Title - Sujet HVAC Upgrade Services	
Solicitation No. - N° de l'invitation EP922-210258/A	Amendment No. - N° modif. 005
Client Reference No. - N° de référence du client CFIA EP922-210258	Date 2020-09-03
GETS Reference No. - N° de référence de SEAG PW-SPWU-183-11872	
File No. - N° de dossier PWU-0-43037 (183)	CCC No./N° CCC - FMS No./N° VME
Solicitation Closes - L'invitation prend fin at - à 02:00 PM on - le 2020-09-08	Time Zone Fuseau horaire Mountain Daylight Saving Time MDT
F.O.B. - F.A.B. Plant-Usine: <input type="checkbox"/> Destination: <input type="checkbox"/> Other-Autre: <input type="checkbox"/>	
Address Enquiries to: - Adresser toutes questions à: Tikhonovitch (RPC), Alex	Buyer Id - Id de l'acheteur pwu183
Telephone No. - N° de téléphone (780) 901-7940 ()	FAX No. - N° de FAX (780) 497-3510
Destination - of Goods, Services, and Construction: Destination - des biens, services et construction:

File: 115303307 Lethbridge Lab AHU Replacement
Addendum No: ADD-M03
Date: September 3, 2020
Owner: Canadian Food Inspection Agency, Public Services and Procurement Canada /
Government of Canada

INTERNATIONAL CENTRE FOR
ANIMAL DISEASES
AHU REPLACEMENT

MECHANICAL
RENOVATION PLAN
MECHANICAL ROOM
MAIN LEVEL

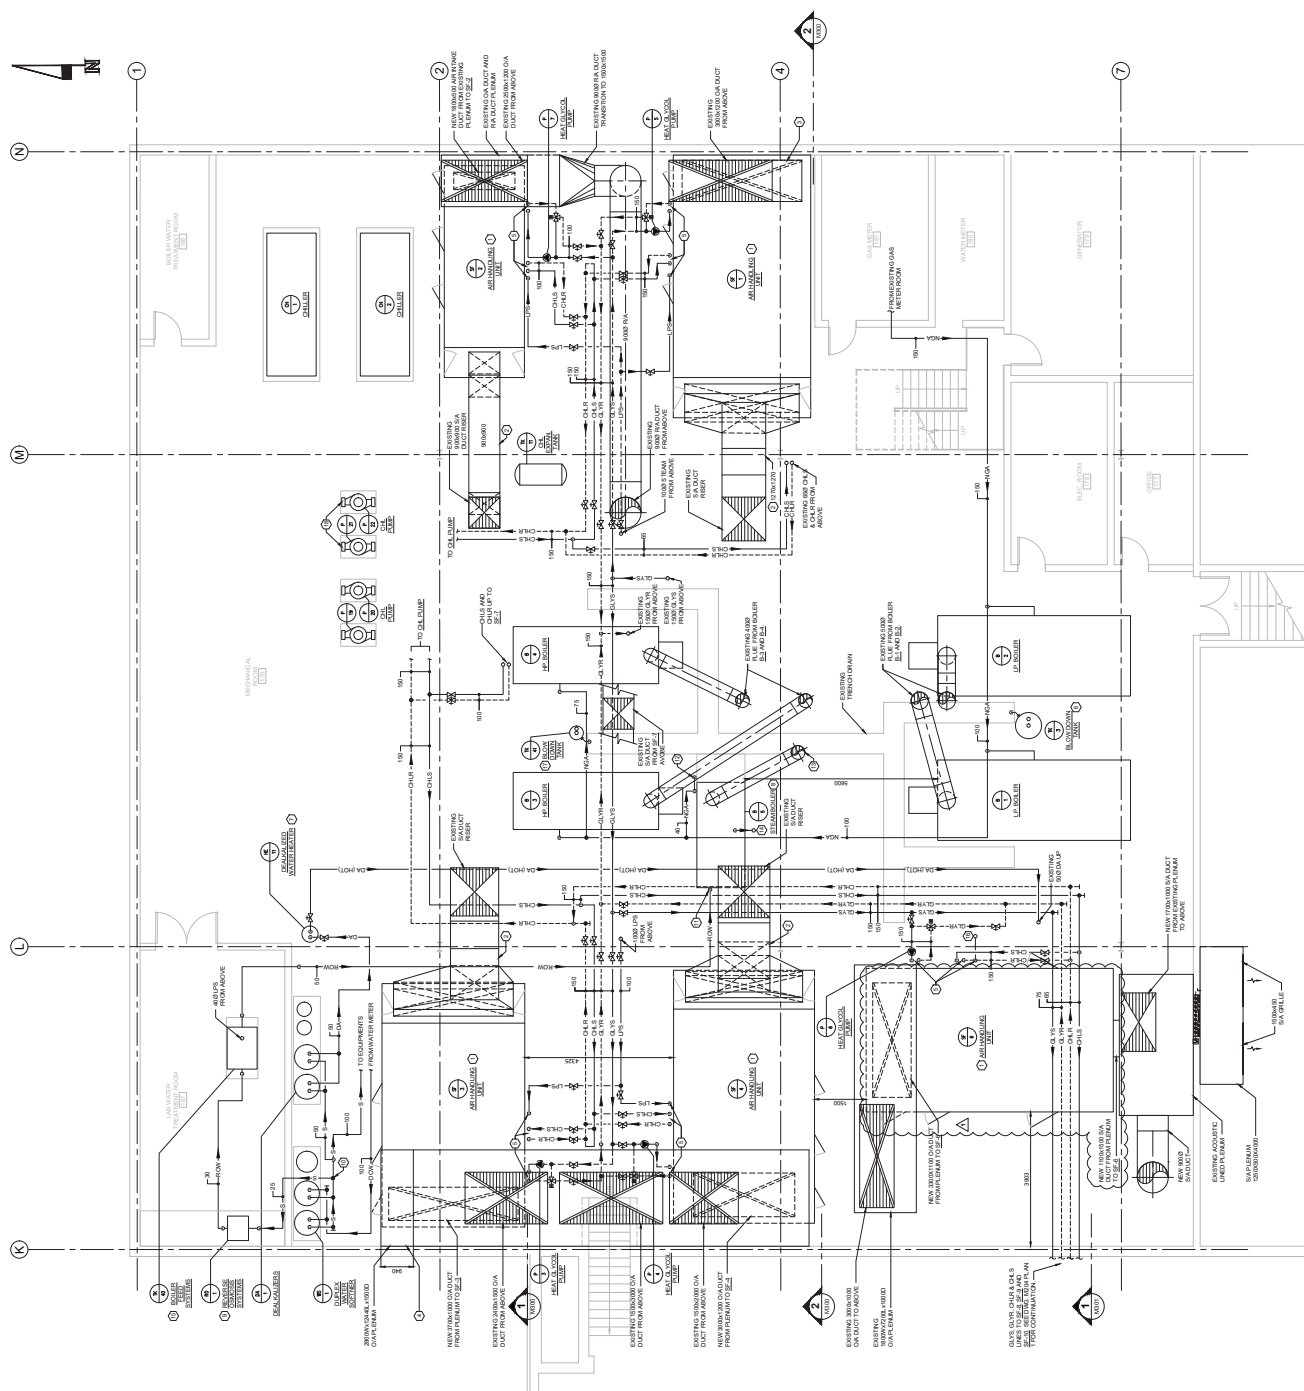
- .1 M200 – MECHANICAL RENOVATION PLAN, MECHANICAL ROOM MAIN LEVEL
 - i. Revised dimensions of SF-6 to match schedules.
- .2 M301 – MECHANICAL RENOVATION PLAN, MECHANICAL ROOM SECTIONS
 - i. Revised dimensions of SF-6 to match schedules.
- .3 M501 – MECHANICAL DETAILS, AIR HANDLING UNITS
 - i. Revised dimensions and weights of air handling unit details to match schedules. This does not affect how units will fit into respective spaces. Updated detail of SF-6 removes dual scroll fans and replaces with single scroll fan as per schedules.
